Access Compliance Report

(Curb Ramps)

| Intersection ID: 18943 | Main Street: GATE_POST_RD | Cross Street: RAMA_RD | Location: | W |
| ADA ID: 5115BBE617D9 | Ramp Type: PerpDiag | Initial Pass/Fail: Fail | Overall Compliance: No | Severity Score: 50 |

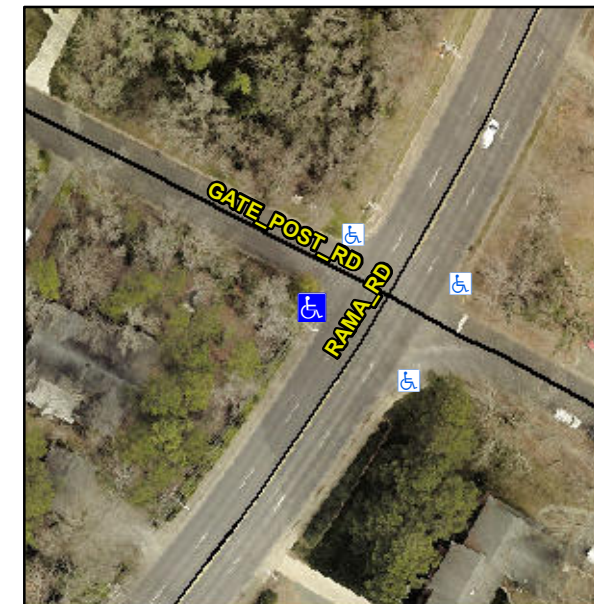
Not Found, R304.2.2, R304.5.3

| Compliance | Description | Data | Compliance | Description | Data |
|------------|-----------------------|-------|------------|-----------------------------|-------|
| N/A | Ramp Length (in) | 46.0 | No | Ramp Slope (%) | 14.9 |
| Yes | Ramp Width (in) | 48.0 | No | Ramp XSlope (%) | 8.2 |

Remove & Replace Curb Ramp With Two New Directional Ramps or Equivalent.
